1. Development Variance Permit No. 00208 for 3147 Douglas Street

Committee of the Whole Report

Subject: Development Variance Permit No.00208 for 3147 Douglas Street

3147 Douglas Street
Development Variance Permit #00208

SHEETING
PARTIAL PLAN, ELEVATION
AND SECTION OF CANOPY
VARIANCE

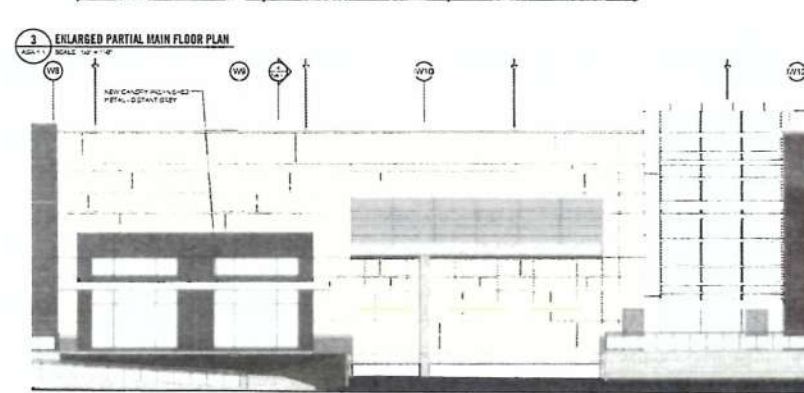
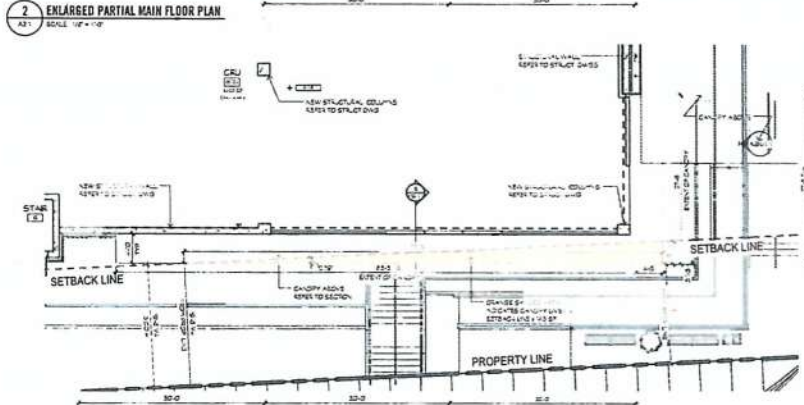
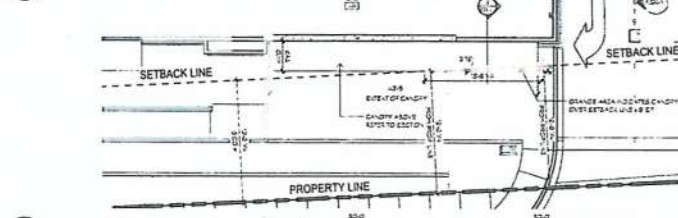
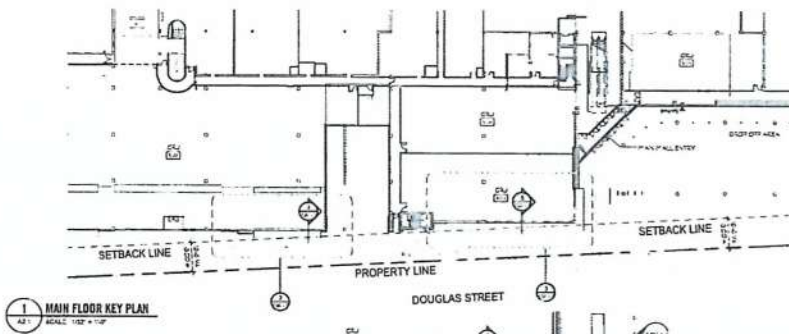
The required setback along Douglas Street is 6.00 metres. The new building addition does not run parallel to the property line. Given the slight angle of the building in relation to the property line, the southern corner of each canopy would encroach beyond the 6.00 metre setback to a minimum setback of 4.85 metres.

1. Plans date stamped January 23, 2018.
2. Development meeting all Zoning Regulation Bylaw requirements, except for the following variances:
 - i. reduce the rear yard setback along Douglas Street from 6.00m to 4.85m for the cantilevered canopies.
3. The Development Variance Permit lapsing two years from the date of this resolution.
